**COMMISSION OF ARCHITECTURAL REVIEW
STAFF REPORT
January 23, 2018, Meeting**

5. **COA-028135-2017-2017** (H. Kellman) **3116-3118 East Marshall Street
Chimborazo Park Old and Historic District**

Project Description: **Construct two duplexes.**

1925 Sanborn Map of the 3100 Block of E. Marshall St.

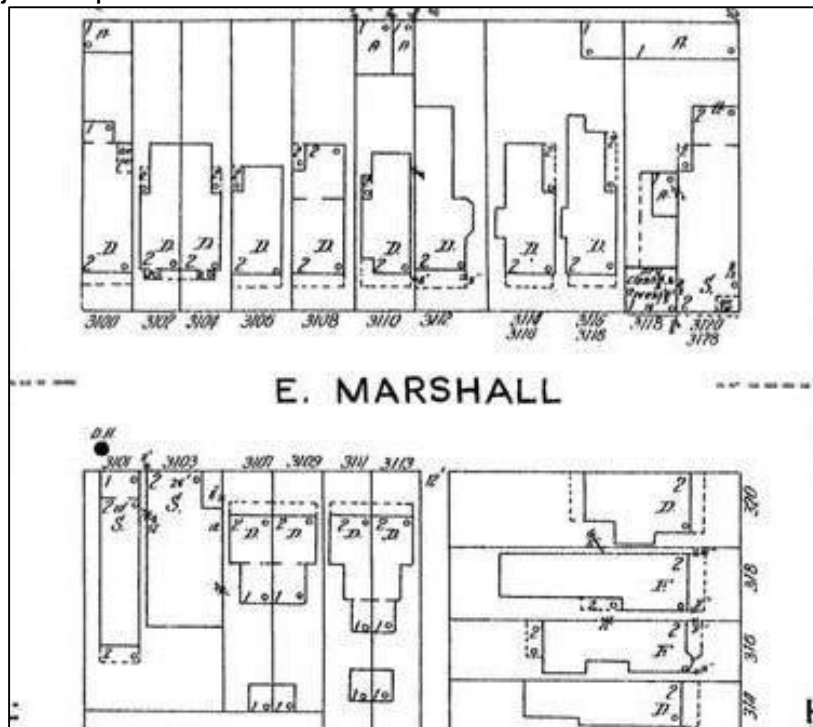
Where the adjoining buildings have different setbacks, the setback for the new building should be based on the historical pattern for the block

The historical setback pattern is consistent with the existing pattern with the commercial structures sitting proud of the residential structures. The proposed setback is not consistent with the historical pattern for the block, though staff believes the applicant has responded to the Commission’s request to more closely align the building with the residential structures on the street by aligning the façade with the front of the adjacent porch
